## Access Compliance Report Public Rights-of-Way (Curb Ramps)

Intersection ID: 18131 Main Street: E\_WOODLAWN\_RD Cross Street: DARWIN\_CR Location: SE

ADA ID: 8E60B88A3A8C Ramp Type: Para Initial Pass/Fail: Fail Overall Compliance: No Severity Score: 1.25

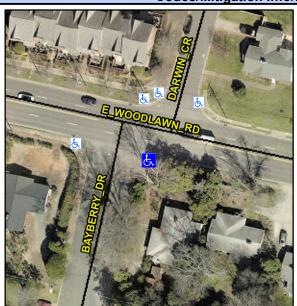
R304.5.3

Remove & Replace Entire Ramp.
